RESPONSE TO PLANNING FEEDBACK

Client: Hopwood Hall College
Project: Conversion of Former Chapel
Reference: 20765-HCO-TC030
Date: August | 2024

**HOPWOOD HALL COLLEGE, MIDDLETON CAMPUS, ROCHDALE ROAD, MIDDLETON, M24 6XH
Application Nos 24/00548/LBC & 24/00547/FUL**

PROPOSED PLAN

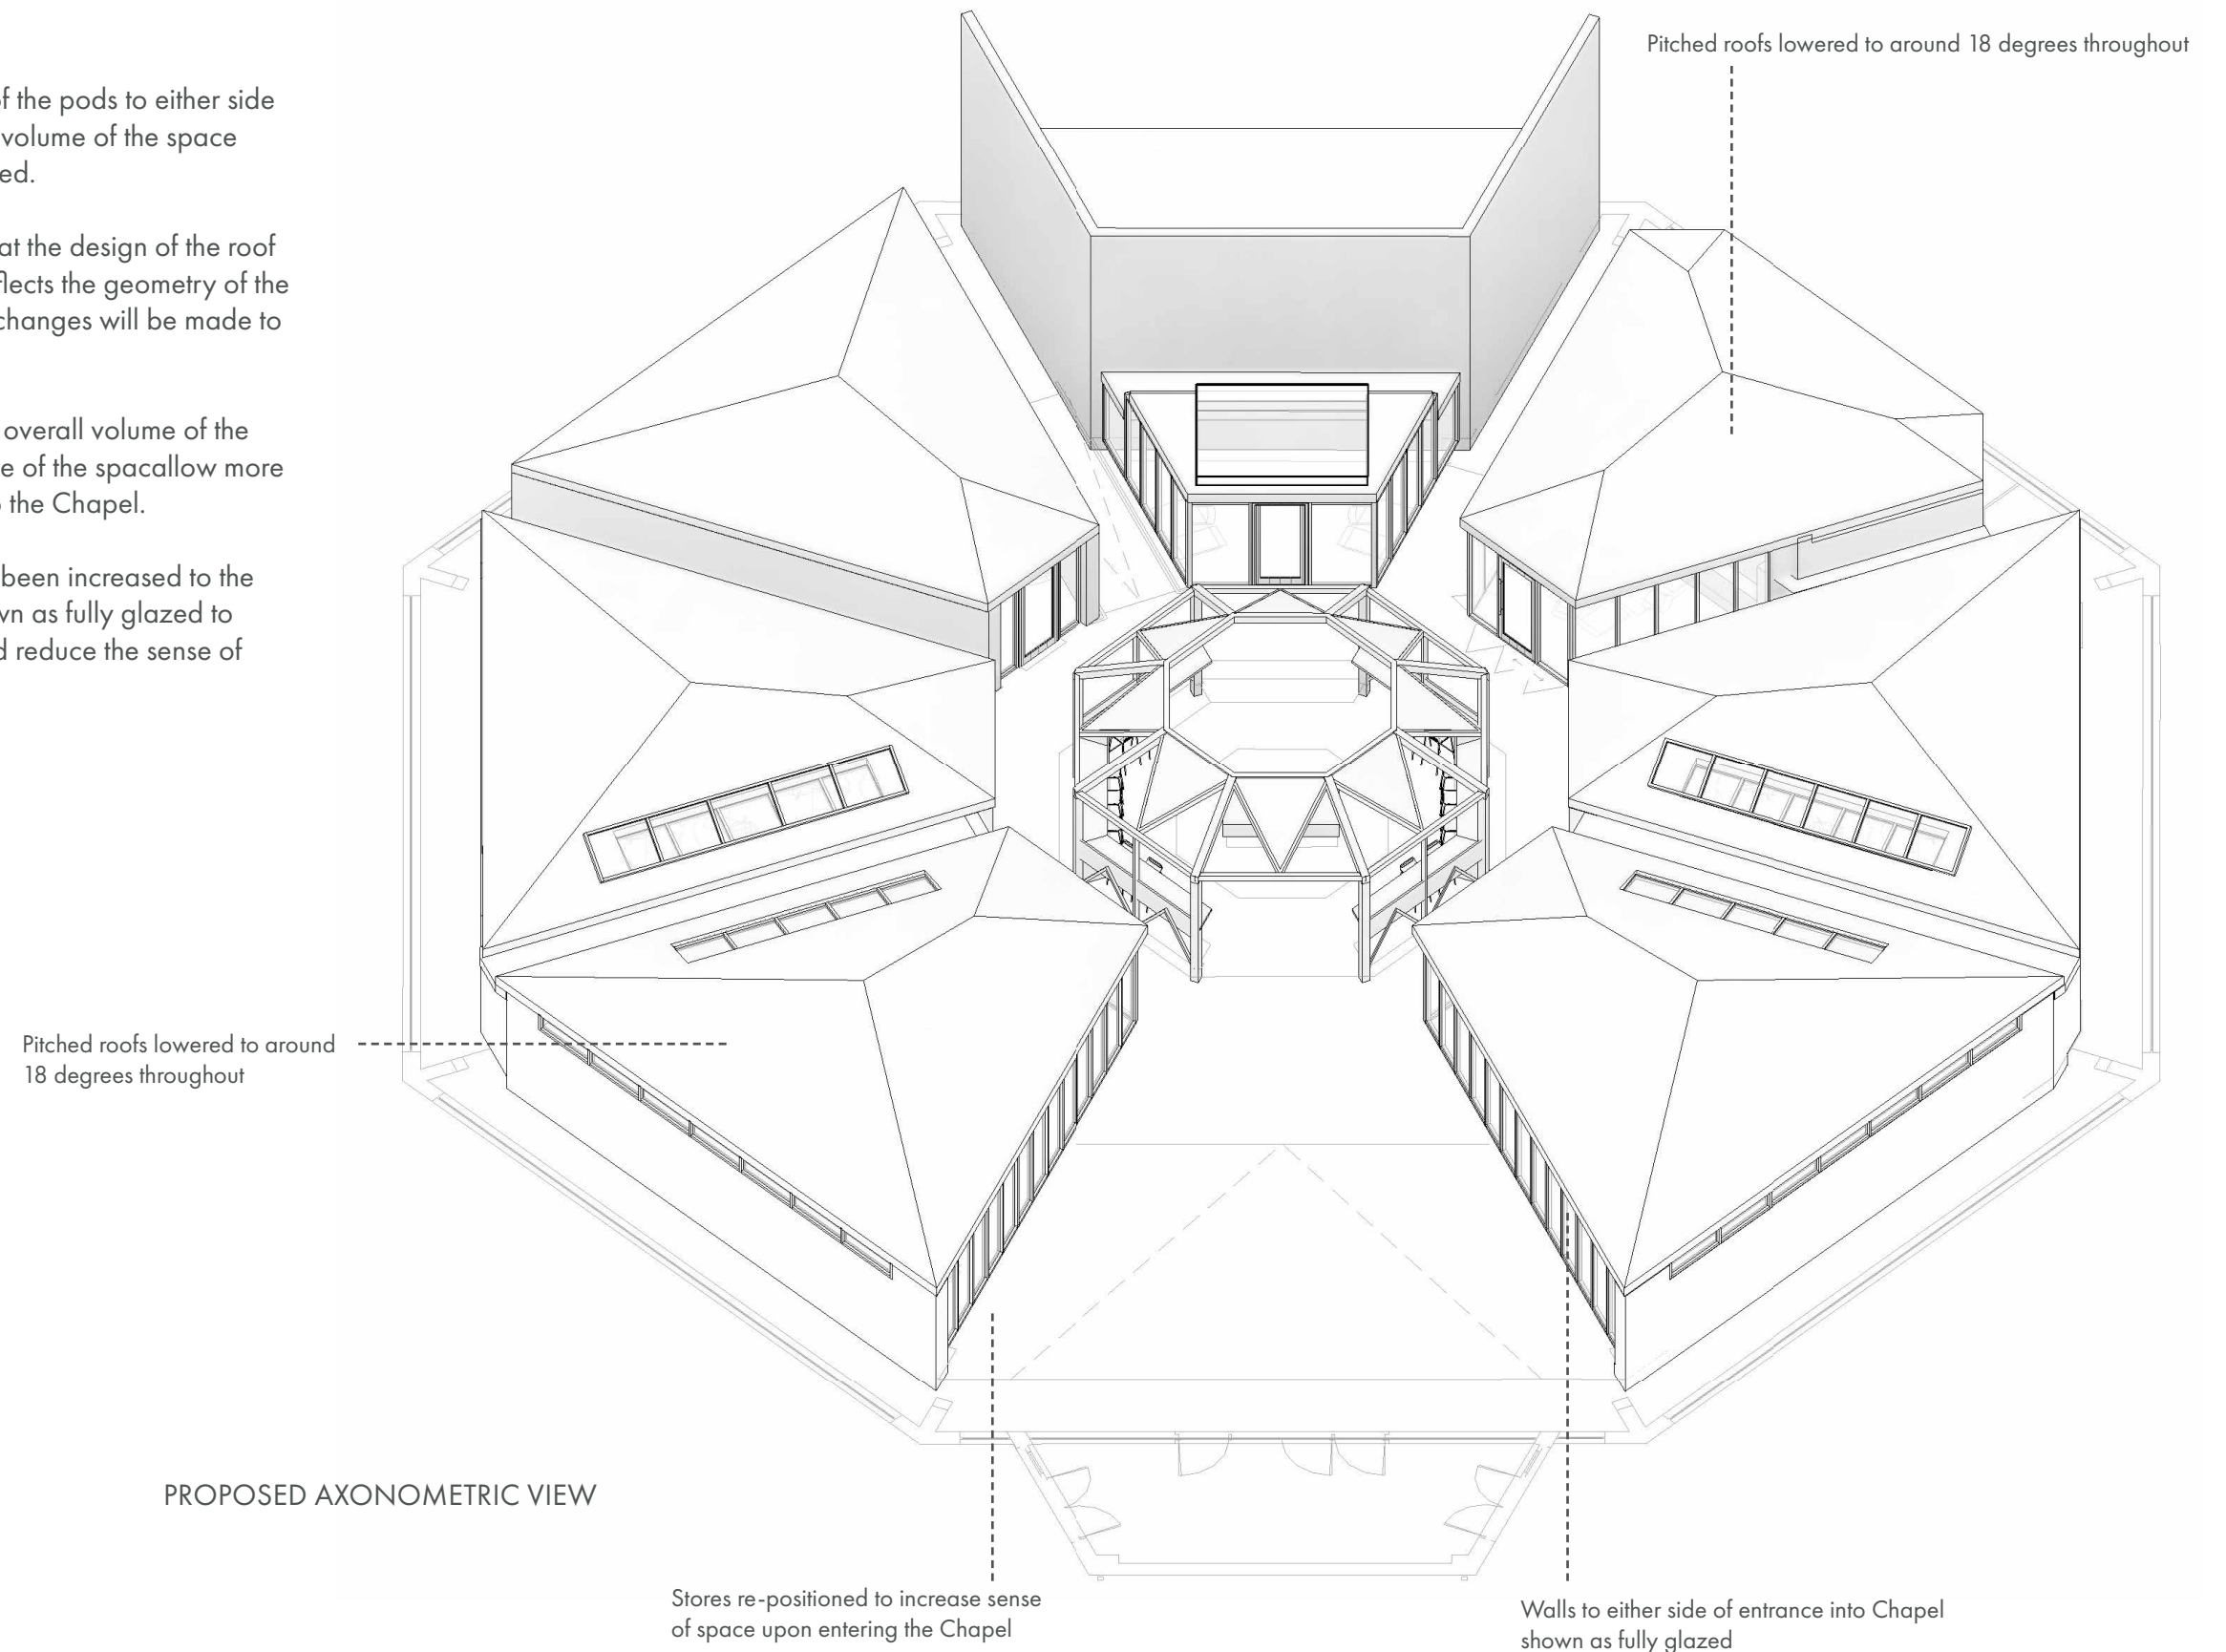
We would encourage the removal or reduction in size of classroom pods to either side of the main entrance to the chapel, to give a greater impression of the volume of the space and to prevent the sanctuary from becoming enclosed. The use of high-quality materials and finishes, with design drawing on the geometric shapes will be vital in sustaining the significance of the listed building.

Consideration has been given to the removal of the two pods to either side of the entrance as requested.

The new stores proposed adjoining the classroom pods either side of the entrance have been shown as re-positioned to help to open up the space as much as possible upon entering the Chapel.

- 1 Cleaner Store relocated
- 2 Laptop Store relocated

Stores re-positioned to increase sense of space upon entering the Chapel

INDICATIVE VIEW FROM ENTRANCE TOWARDS SANCTUARY - REVISED PROPOSAL WITH LOWER ROOF PITCH AND ADDITIONAL GLAZING

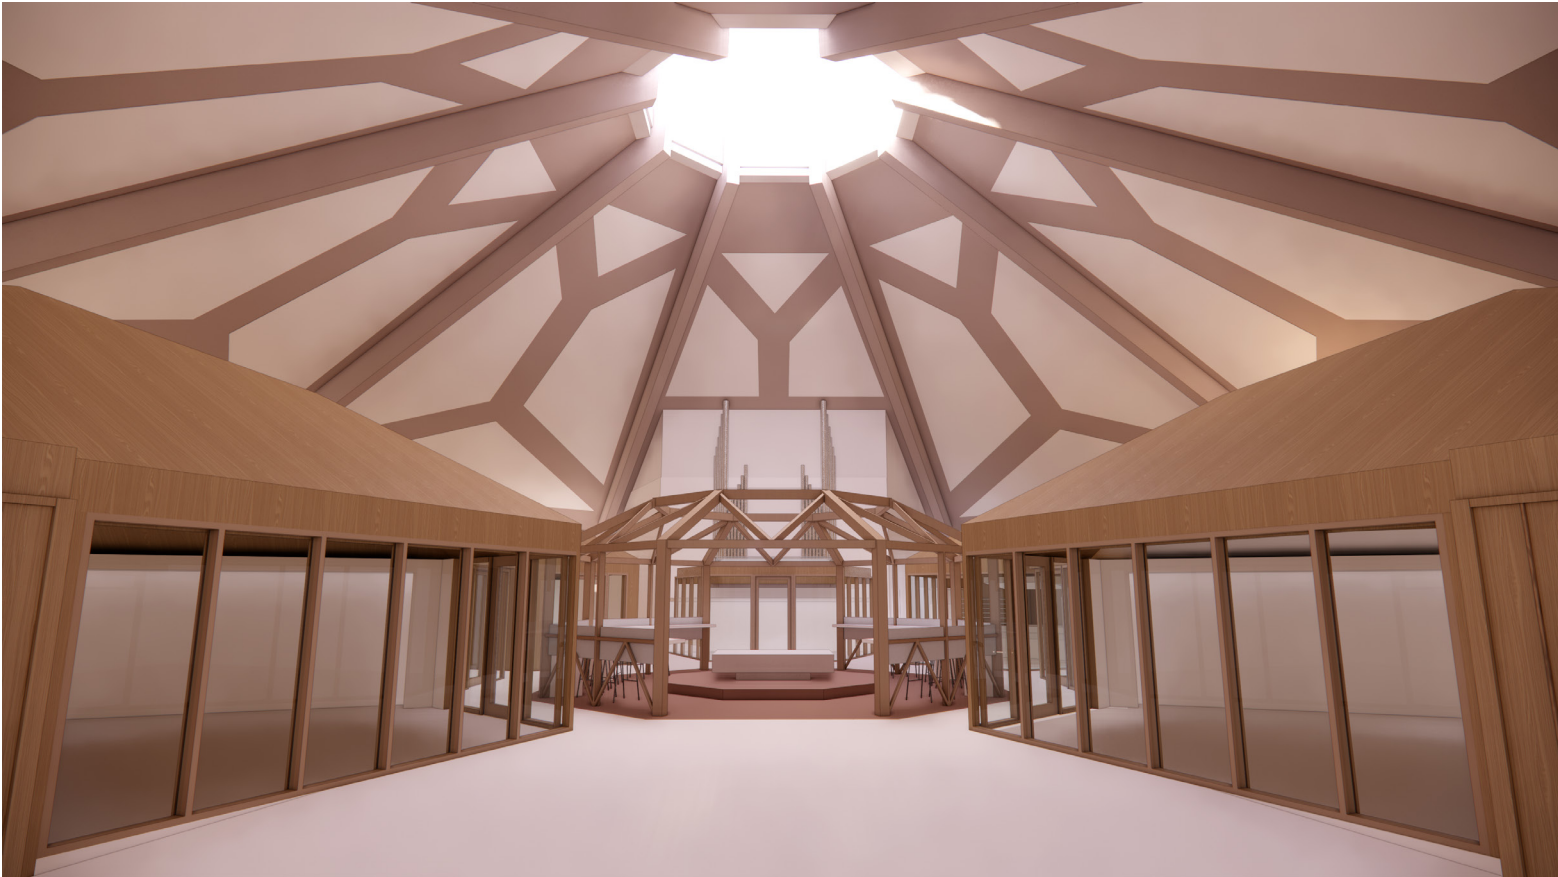
Further consideration has been given to the design of the pods to either side of the entrance, to allow a greater impression of the volume of the space and to prevent the sanctuary from feeling too enclosed.

1. The pitch of the roof is reduced to help reduce the overall volume of the pods and to allow a greater impression of the volume of the space allow more of the original fabric to be visible upon entrance into the Chapel.
2. The amount of glazing to the classrooms has also been increased to the walls either side of the entrance. These are now shown as fully glazed to help increase the visual permeability of the pods and reduce the sense of enclosure upon entrance into the Chapel.

Pitched roofs lowered to around 18 degrees to allow increased views towards the original roof structure

Increased glazing to improve visual permeability

A series of images are included opposite which illustrate the current condition of the roof, taken from Drone Survey footage in January 2024.

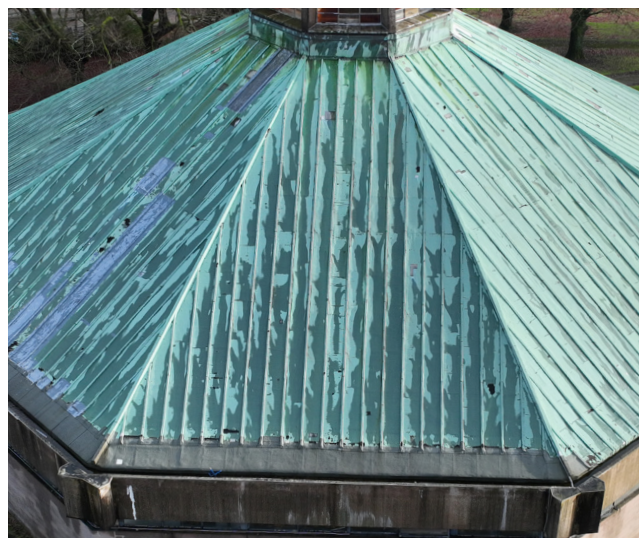
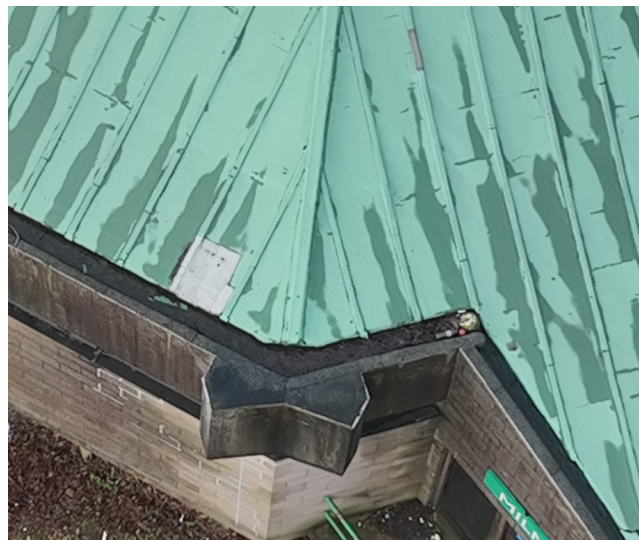
Our preference from a heritage and cost perspective would be to retain and repair the existing copper roof and cladding. However, it is proposed to replace the existing copper roof covering as this is considered to be beyond economic repair.

- *Reviewing the images we think the copper has passed its sell by date and would not be suitable for reuse.*
- *There are a number of failures and repairs over the sheets and this would indicate there would be little benefit in trying to save some sheets.*

- *It is my opinion that the roof is in need of complete replacement.*

Consideration has been given to the retention of the existing copper and overlaying this using a new copper roof in order that the historic fabric is preserved. However, it is felt that the retention of the copper in it's current condition could potentially cover up ongoing issues with moisture ingress which would be detrimental to the building fabric going forwards.

PROPOSED AXONOMETRIC VIEW

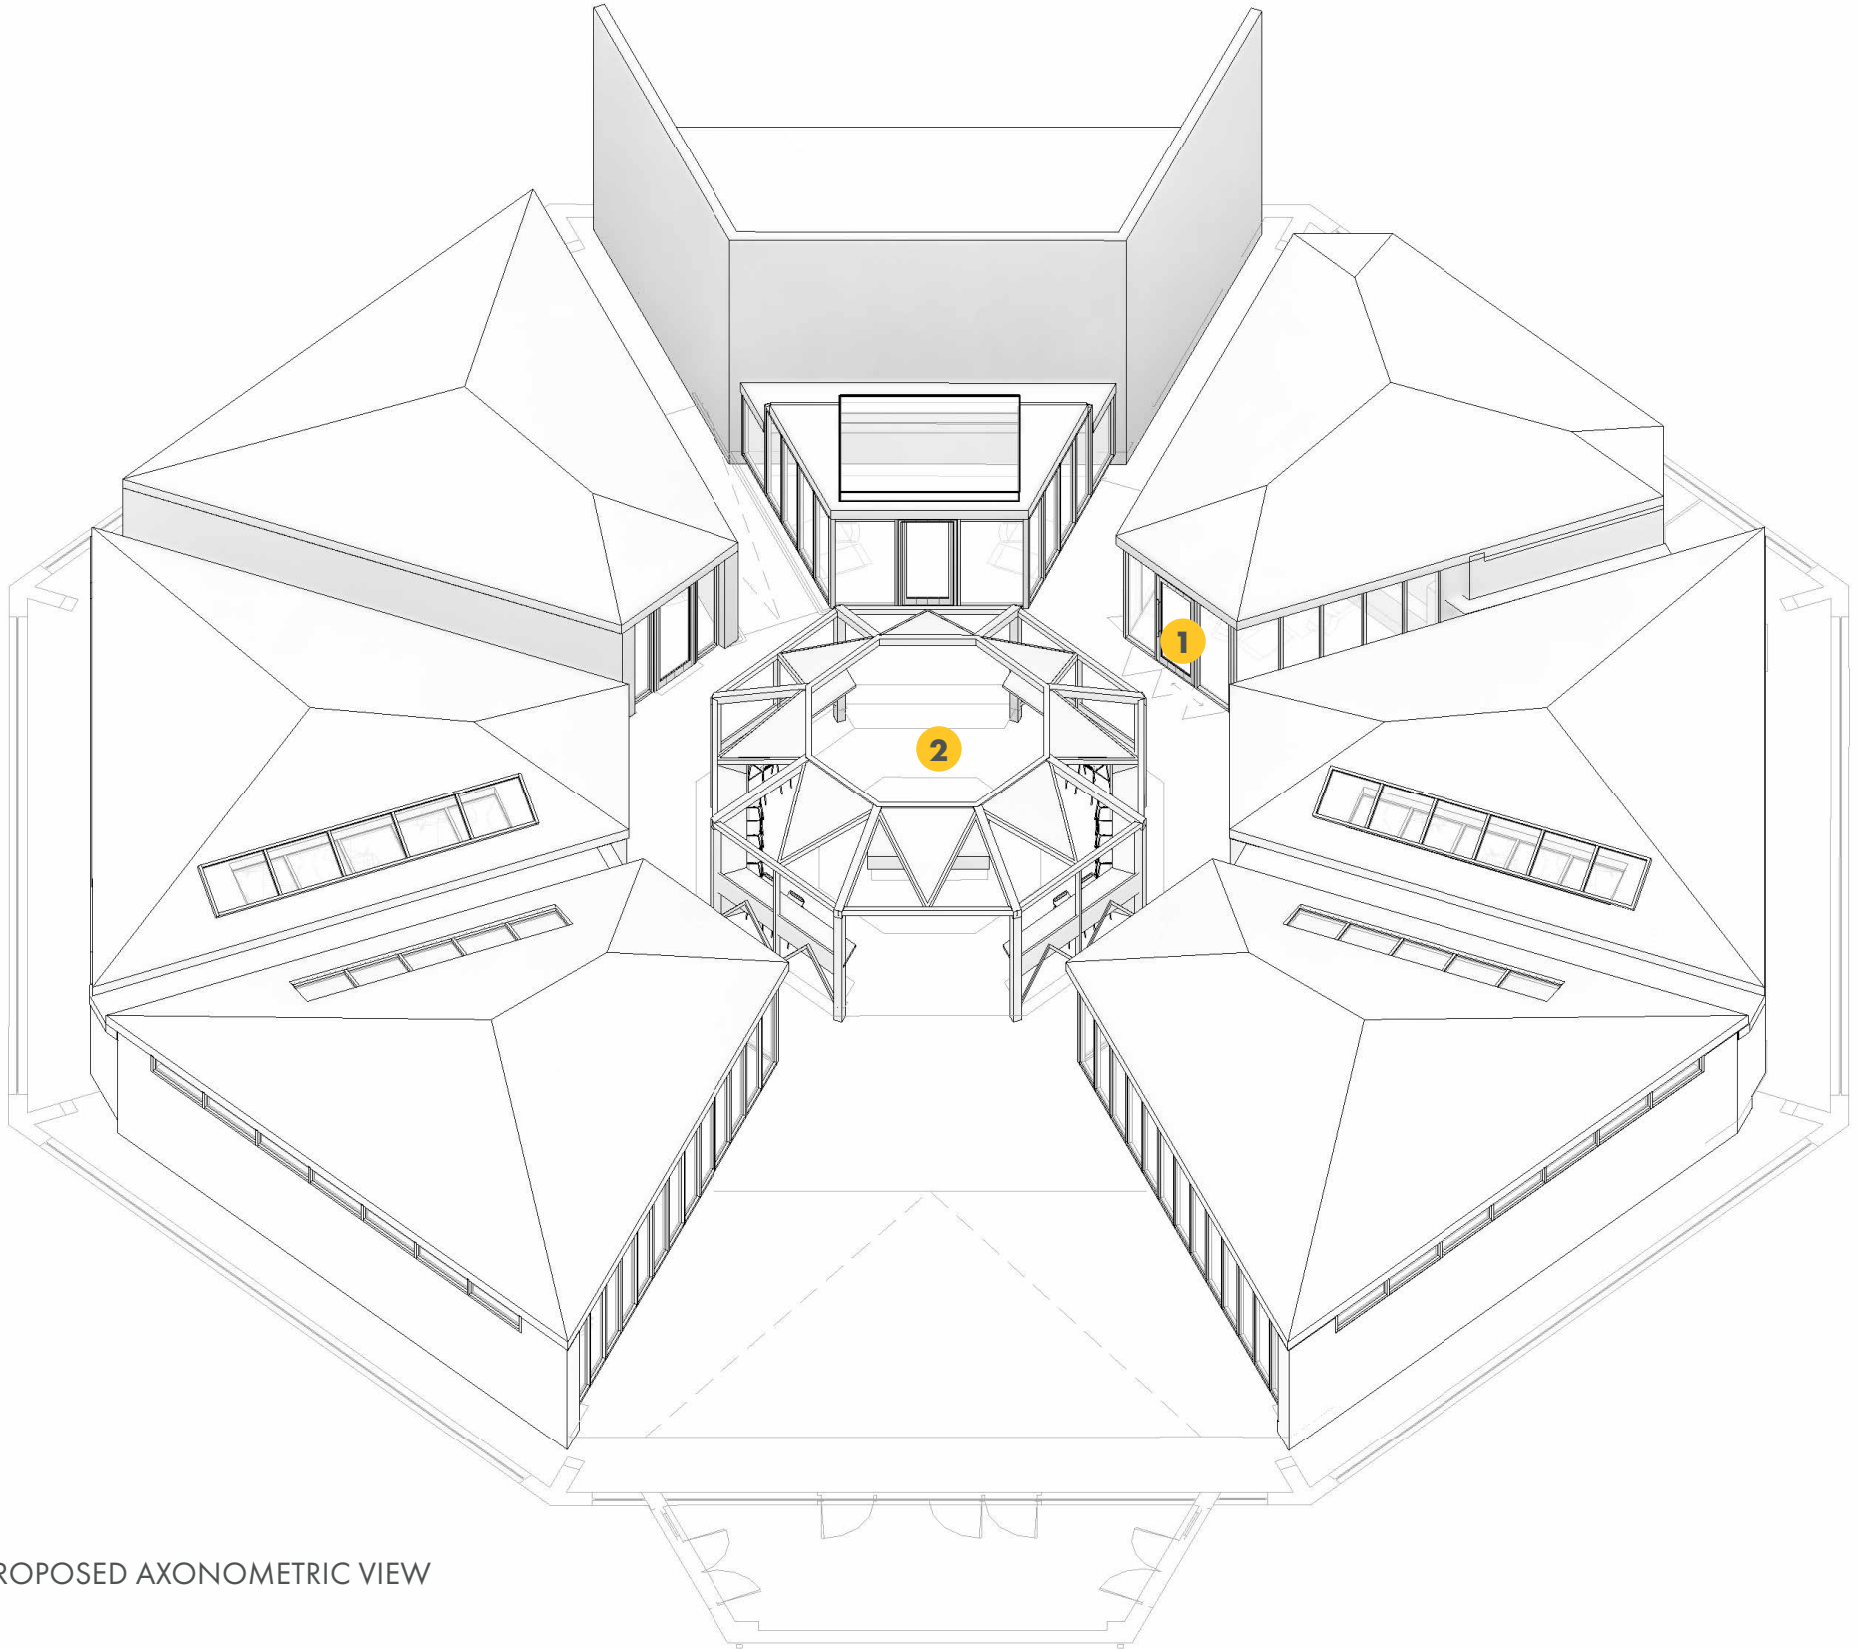
We do however have concerns about proposals to enclose the Blessed Sacrament chapel to create an immersive VR space and staff office. We feel that this chapel should be left unenclosed and remain

visible from the centre. The section of the new canopy around the altar could be opened up to that side too. This would allow the interesting existing canopy feature over the Blessed Sacrament altar to appear in its intended relationship with the main altar.

It is therefore proposed that this pod is retained but that the design is amended to increase views towards the Blessed Sacrament Chapel and to help preserve the relationship between this and the central altar. The following amendments are proposed:

1. Glazed walls to the office pod are amended to bi-folding doors system to allow these to be fully opened up to minimise the enclosure of the altar and canopy.
2. Sanctuary area amended to re-position the entrance into the Sanctuary area to sit opposite the side chapel - helping to reinforce the historic relationship between the central Altar and the Blessed Sacrament Chapel.

- 1 Bi-folding doors to Office to reduce the sense of enclosure to the Blessed Sacrament Chapel
- 2 Amendments to Sanctuary area to reinforce the relationship between the central altar and the Blessed Sacrament Chapel
